**From:** Rob Swartz [mailto:rswartz@rwah2o.org]  
**Sent:** Tuesday, December 10, 2013 8:57 AM  
**To:** Brewster, Bill@DWR  
**Cc:** jwoodling@rwah2o.org  
**Subject:** Comment on CWP Sac River HR draft

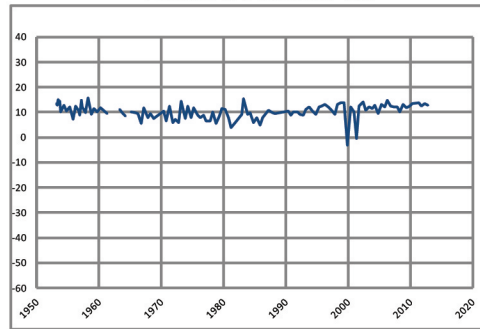
I am writing to provide a comment on Figure SR-19 (Spring 2005 - Spring 2010 Change in Groundwater Elevation Contour Map for Sacramento River Hydrologic Region). I note that there is a small cone of depression noted in the map in the vicinity of Carmichael just north of the American River in Sacramento County. I am concerned that this area is not indicative of trends that we have observed as part of our basin management assessment at the Sacramento Groundwater Authority. I am attaching a figure that shows trends that we have observed through 2012. We do not have any indication that groundwater elevations declined during that period to warrant the decline noted on figure SR-19.

During our preparation of our basin management report in 2010, we reviewed long-term hydrographs and determined that well 09N/05E-12L001M was displaying observed water levels that were not consistent with any adjacent wells. At that time, we decided to exclude that well from our monitoring and analyzing efforts.

I assume that this may also impact your change in storage calculation as well.
